MEMORANDUM

TO: District of Columbia Board of Zoning Adjustment
FROM: Maxine Brown-Roberts, Project Manager
 Joel Lawson, Associate Director Development Review
DATE: November 25, 2014
SUBJECT: BZA Case 18994, 3509 Patterson Street, NW, NW

SITE PLAN

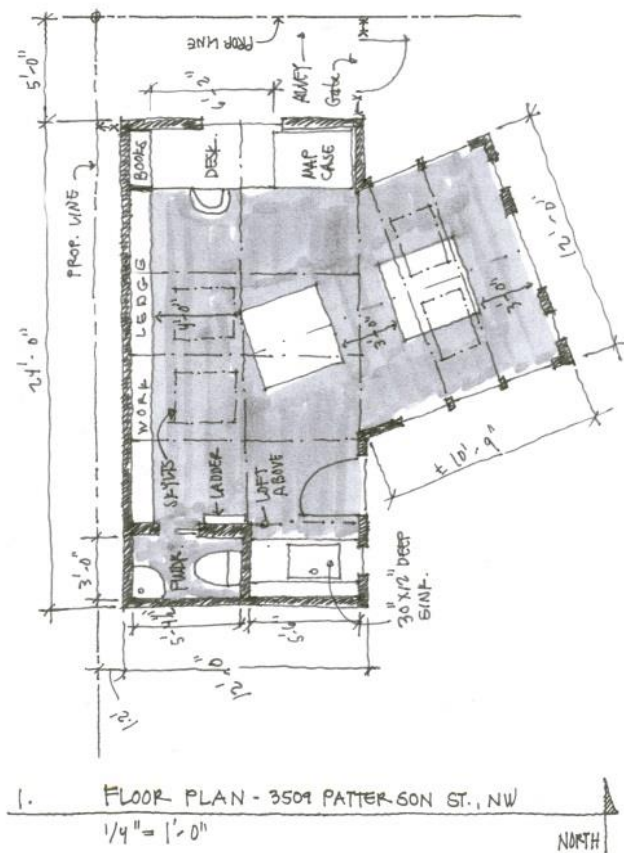
The applicant proposes to replace the one-story structure at the rear of the property, maintaining the current 1.2 foot side yard and reducing the rear yard setback to 5-feet. The structure would maintain its adjacency to a garage on the adjacent property and would be of similar height. The location and the layout of the proposed building are designed to preserve a large tree in the rear yard. Most of the existing landscaping is intended to remain on the property to help screen the addition from adjoining neighbors. The proposed height and area of the structure would not affect the light and air of adjacent residences or rear yards along the alley.

The reduced side yard would be adjacent to a neighboring garage that has no windows. Windows on the side of the proposed structure that would face adjacent properties would be placed high so as not to permit direct views into adjacent properties or to intrude upon their privacy of use or compromise the enjoyment of their properties. However, the windows would allow light and air into the studio.

The proposed studio would be visible from the public alley but not from Patterson Street as it would be screened by dense landscaping along the property line. The building material would be similar to the main house and it is not anticipated that the proposed additions would substantially visually intrude upon the character, scale and pattern of houses along the adjacent public ways.

The Applicant has provided drawings, including site plan and elevations, and photographs, which sufficiently represent the relationship of the proposed addition to adjacent buildings and views from alley.
